TTI Performance Exhaust and Headers  
Tube Technologies, Inc.  
Corona, California 92880-1726  
Phone (951) 371-4878

Sheet #101 / Footnote #36

### 3-section throttle rod swivel assembly modification

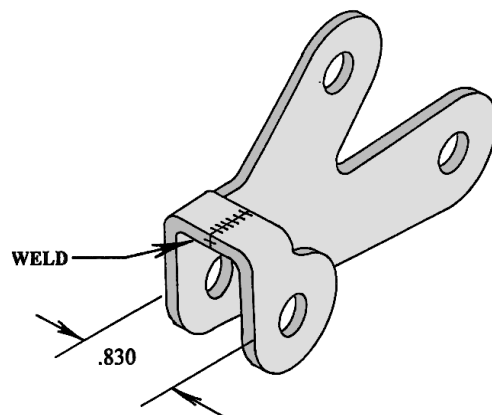
Applications with a 3-section throttle rod may require modification to the bell-crank and the pivot shaft to clear the header tubes or exhaust pipes.

Big Block Headers: Modification may be required when installing some headers.

Exhaust-pipes (to stock manifolds): Modification will be required when installing listed pipes; A25LE, E25LE3 and E30LE3.

1. The bell-crank and the pivot shaft must be shortened by 3/4".
2. Weld the bell-crank back together as shown.
3. Re-bend the lower throttle rod as shown.
